PLAYHOUSE PLAZA

680 East Colorado Boulevard
Pasadena, California

Gensler

April 26, 2010

MOTION 1 - PEDESTRIAN CONNECTOR TO PASEO

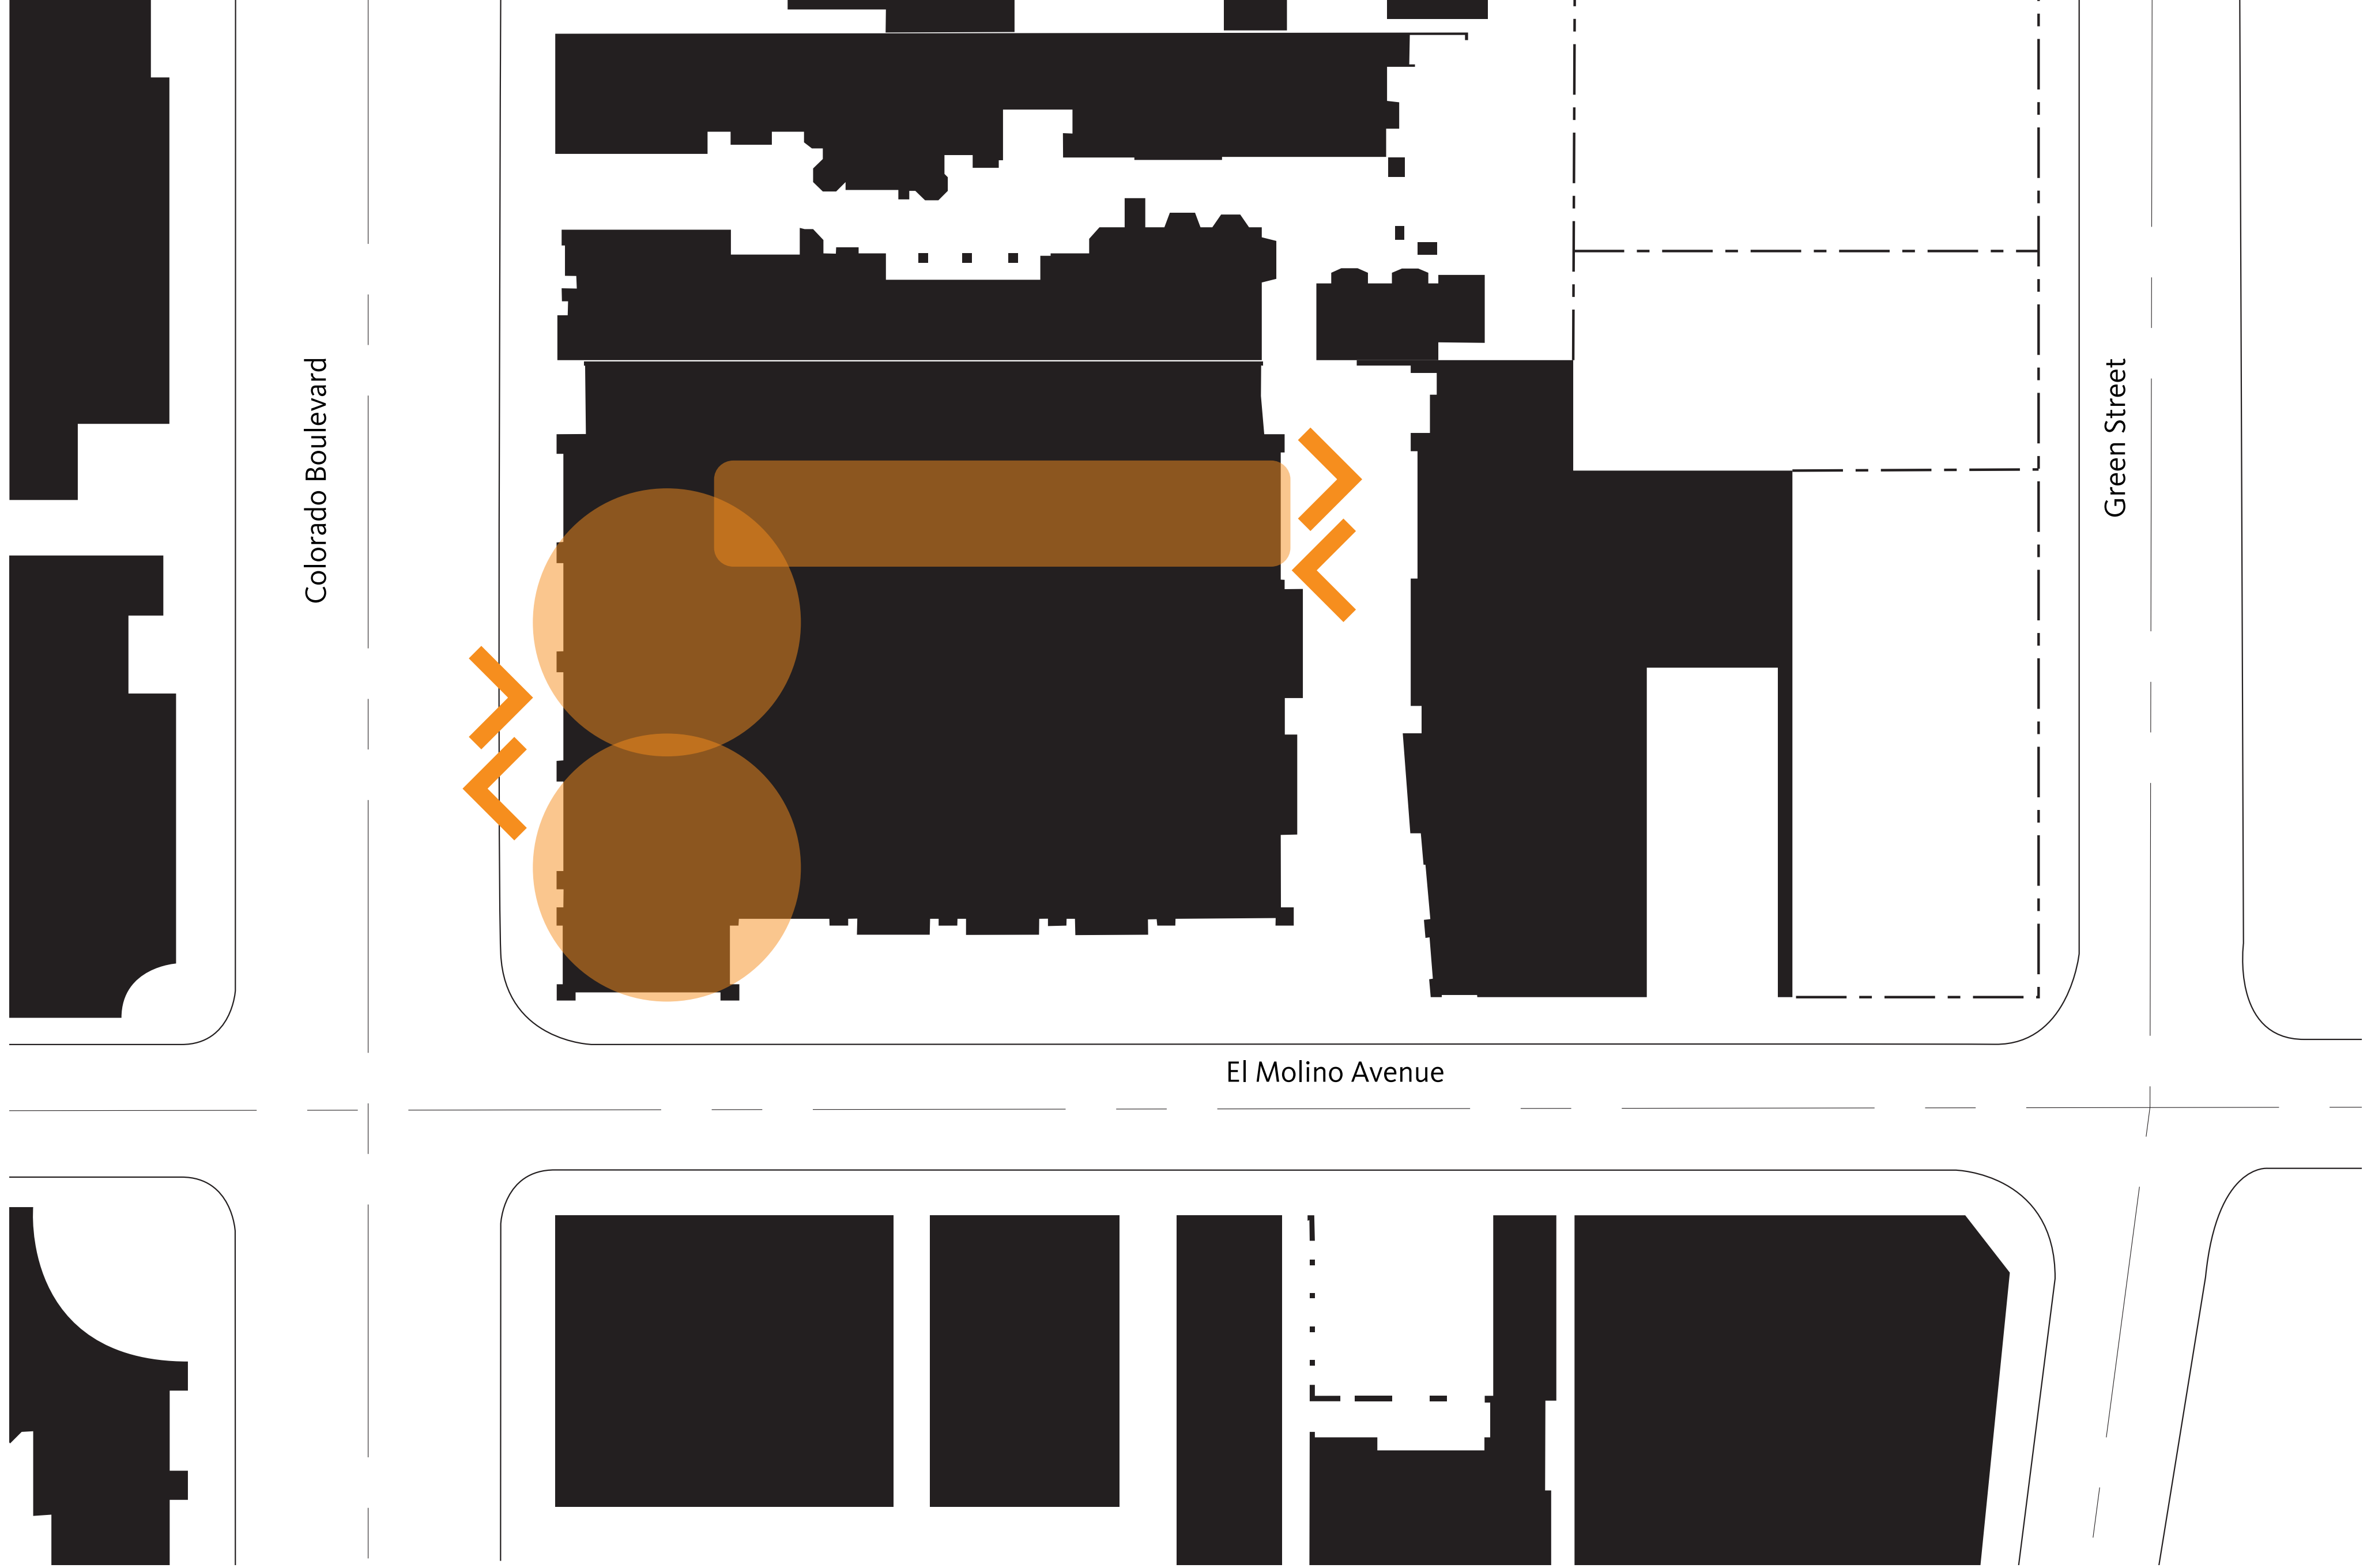
Restudy an entrance on Colorado Boulevard at the center of the building. **The kind of entrance that would activate the paseo and make some kind of connection from the building to the paseo (and Arcade Lane).**

PAVILION OPTION [4.12.2010- DESIGN COMMISSION PRESENTATION]

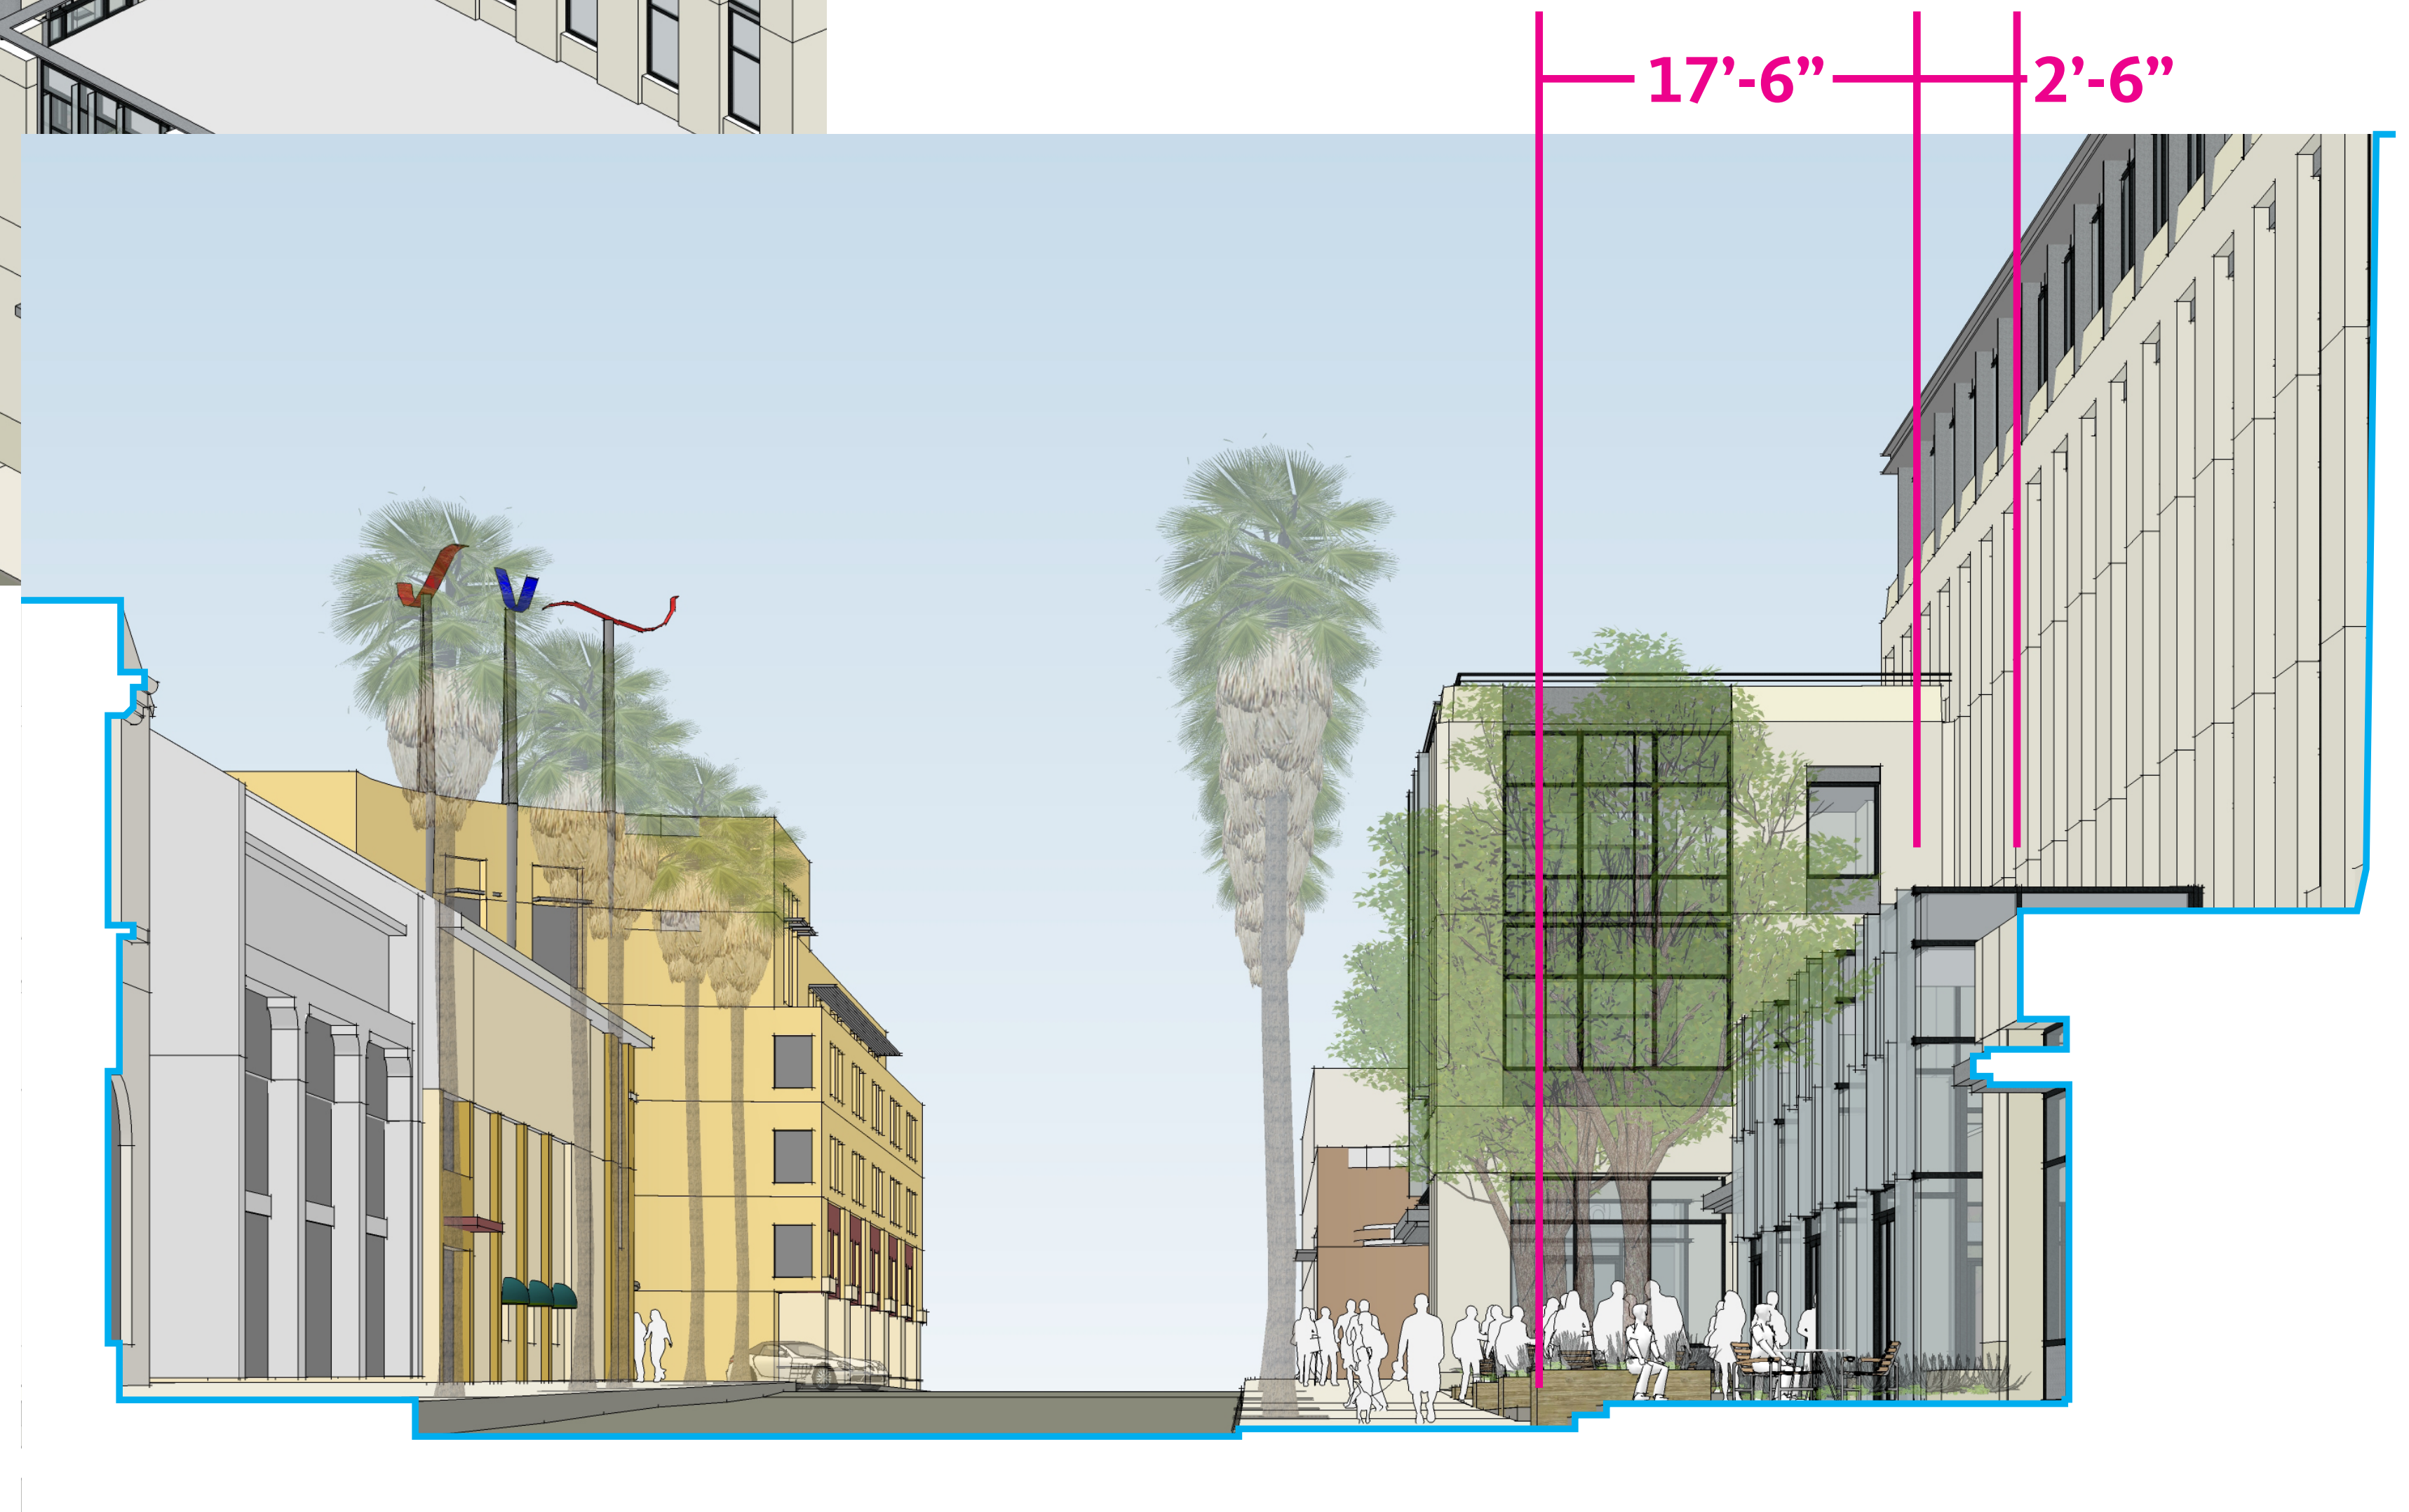
Restudy the possibility of having pavilions along El Molino Avenue and how they would interact with pedestrian circulation along El Molino.

CORNER TOWER ARTICULATION

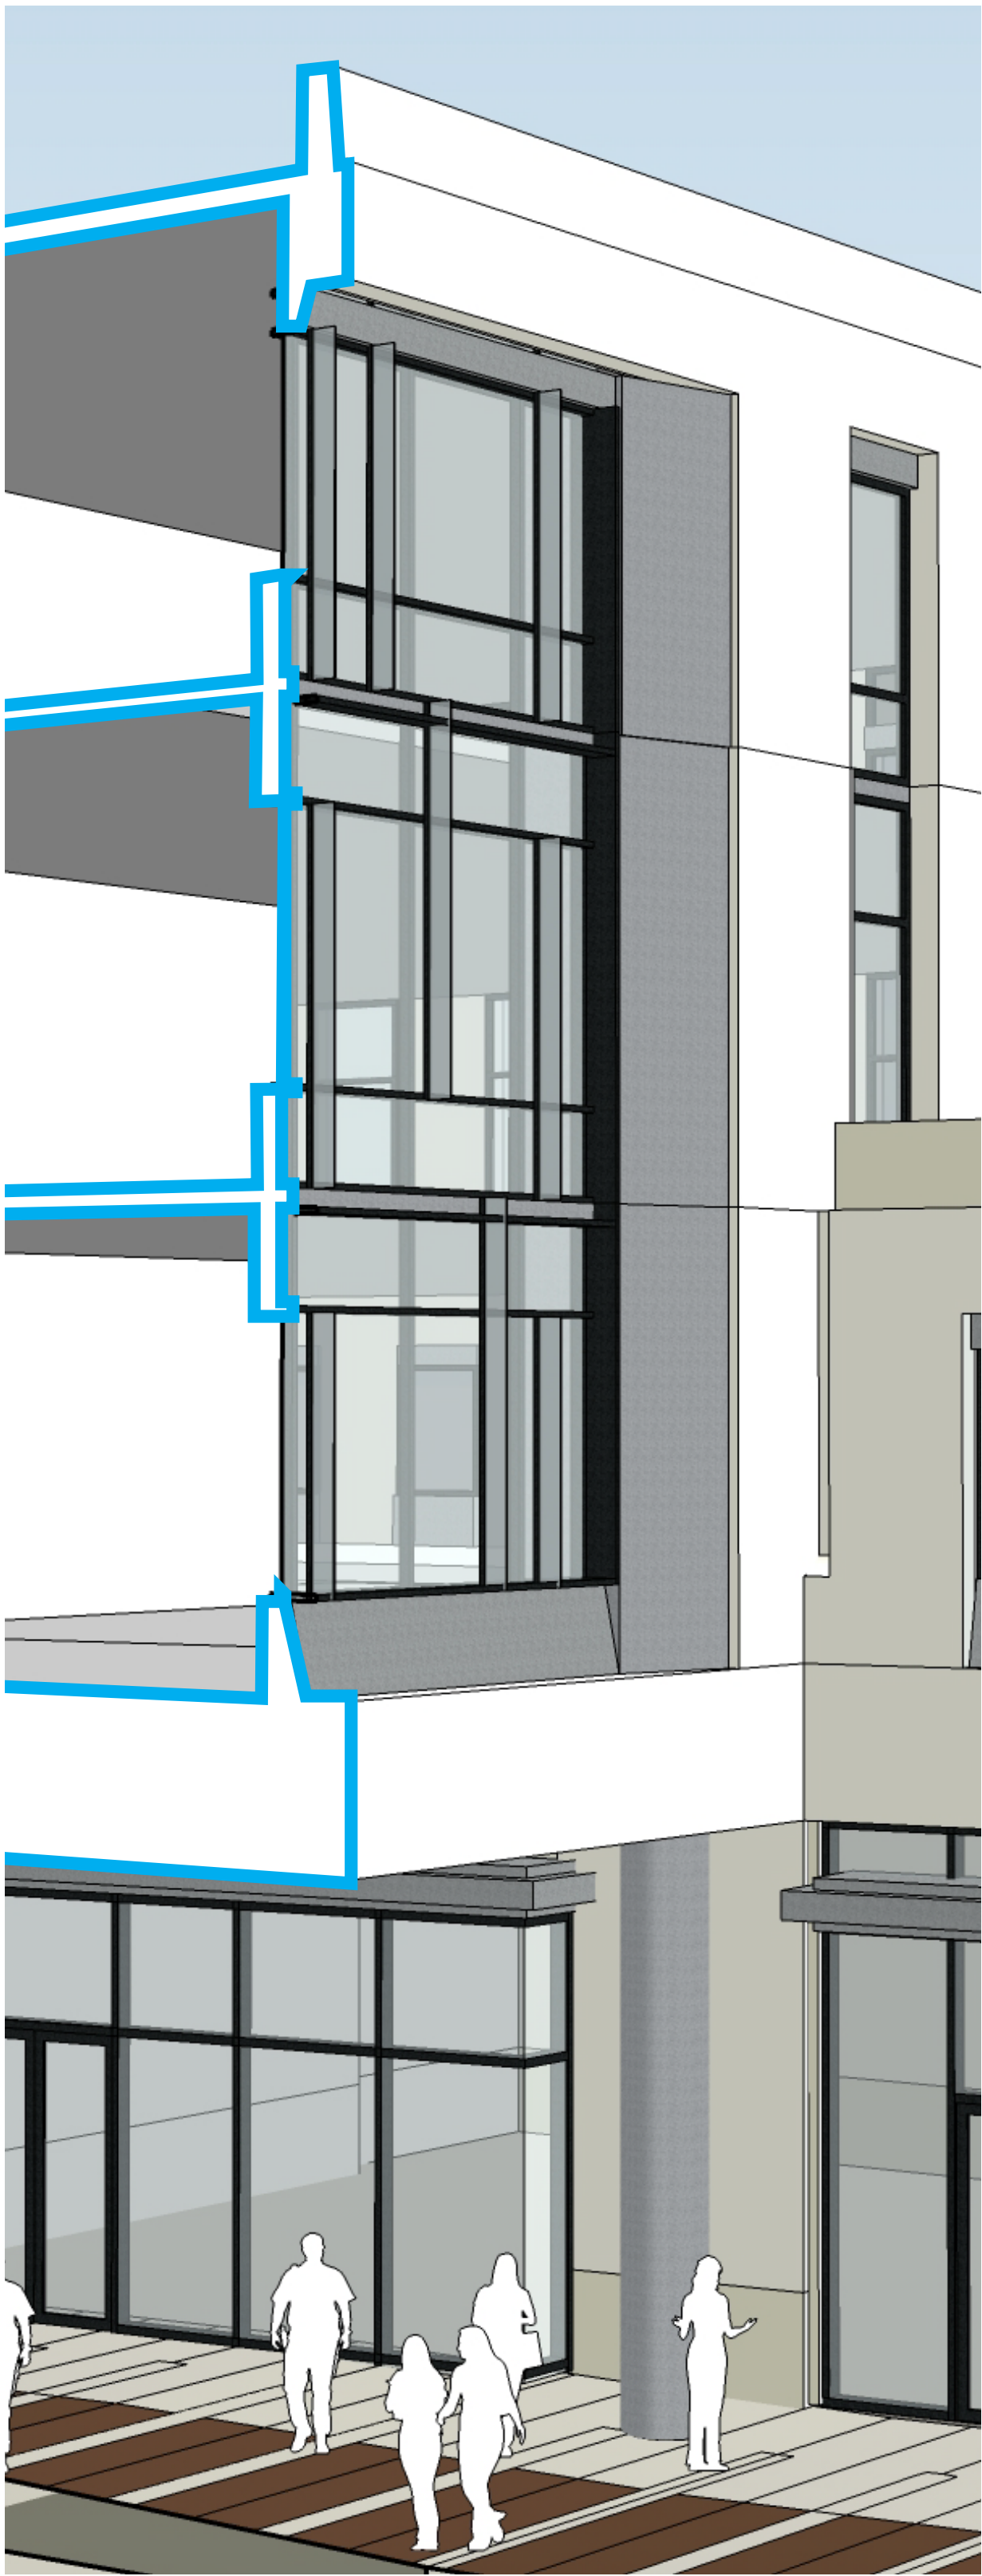
To further refine the terminus of the corner tower on Colorado and El Molino to insure the specifications for glazing, finish details, and locations for preliminary signage are well resolved for final design review. Specialty lighting should also be considered for this portion of the project.
